Petition Number: #2021-198

General Location Identifier: Tax ID 18712322

### **Transportation Summary**

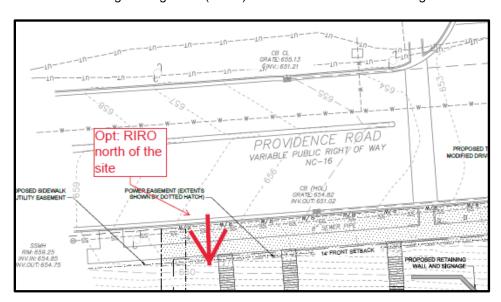
Providence Road: The future curb line will be located 41' from the center line to the back of curb; however, the curb line will remain in its current location.

Label and dimension the existing and future curb and gutter from the centerline for each road on the site plan.

Clarifying comment 2-22-23: Per email exchange on 1-23-23, CDOT has informed the developer that the future back of curb is 33' from centerline. Site plan is currently showing 30' and suggesting the current curb and gutter is in the future location, this is incorrect. Adjust planting strip and 12' MUP accordingly.

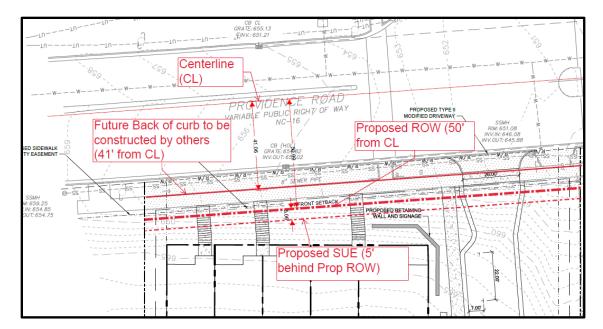
- 4. Outstanding Comment from 12-23-21 Revise site plan and conditional notes to commit to dedicate 50-foot right-of-way from the Providence Road centerline. The site plan shall label and dimension the right-of-way from the road centerline. (refer to Note 6. figure)
